m/29/001

12 November 2001

Re: Conditional Tentative Approval of Large Mine Plan Permit Revision, Holnam, Inc., Devil's Slide Quarry, M/029/001, Morgan County, Utah

Photo #1: Riprap channel east side Quarry #1

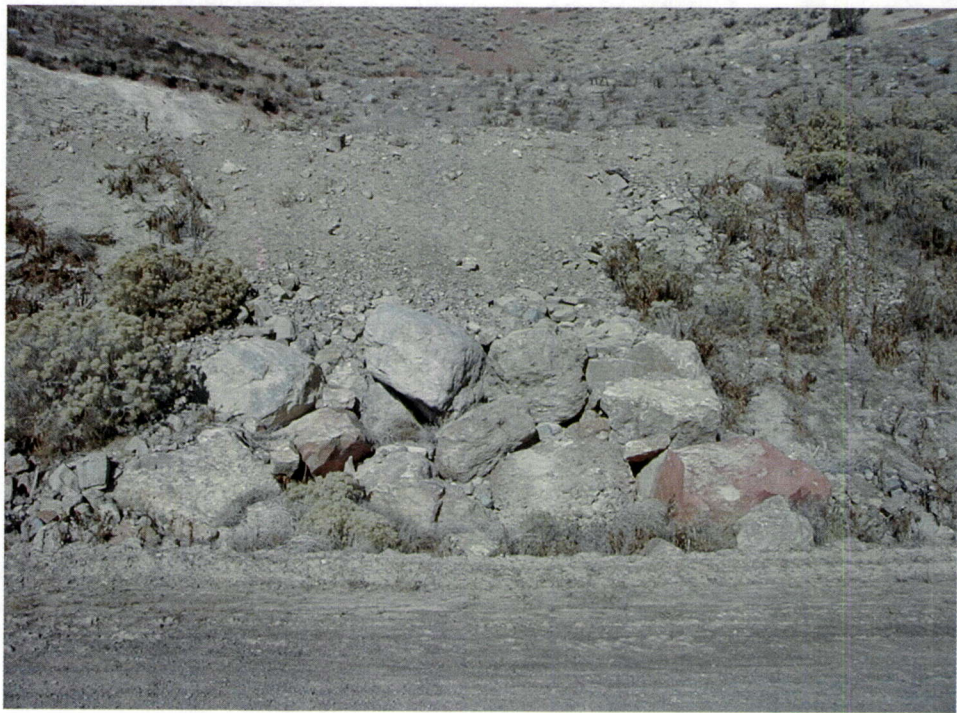
The plan failed to provide a cross section of the 800-foot long culvert, which will be placed in the drainage instead of the 40-inch rip rap channel. A typical cross-section of the proposed culvert installation will be required. Design information related to the culvert is also lacking. Please provide culvert dimension, energy dissipater dimensions, and other appropriate construction details. (TM)

Holnam has decided to not install an 800 foot long culvert in the aforementioned application, in fact, the consultant added that feature to the permit revision without approval of Holnam and it was missed during our review. We intend to install the 40-inch riprap channel instead of the 800-foot long culvert. Attached as an example of the construction of the riprap channel are several photographs (Appendix A) on the existing permitted area where these channels have been constructed using the "French Drain" BMP. These practices have proven to be very successful in other stripping dump and runoff areas on the main mine site and have been implemented on slopes equally as steep as ditch segment 2 (DA-1S (sloped fill), Map R647-4-111.2b).
